Subject: Deflector-angles at the C.G. release
Usage of connection ring pair meeting standard LN 65091

Affected: All glider manufactured by Glasflügel

The technical content of this
TN No. 5-2018 is EASA approved.

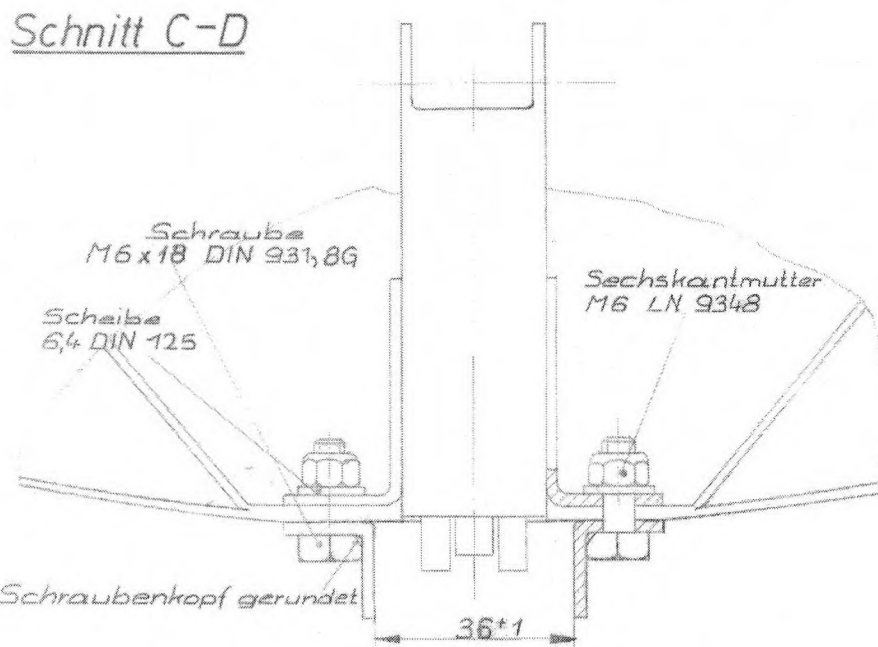
Reason: Jamming of the double-ring pair between the deflector-angles at the C.G. release.

1. Verification of the distances and the parallelism of the deflector-angles by means of a caliper or gauge with 36 mm width as shown in the attached drawing
2. If the distance between the deflector-angles is less than 36 mm, remove the deflector-angles and file the holes till the distance is right.
Pull the deflector-angles with a distance-piece of 36 mm together and support them with filling material as resin with cotton flocks or polyester putty. Positioning it with the screws. After curing, screw the release and the deflector-angles as shown on the drawing.
Finally, a function test and release test must be done.

3. Insert the following Note into the flight- and maintenance-manual under winch tow: „Winch launching is permissible only with connecting ring pair according to LN 65091“
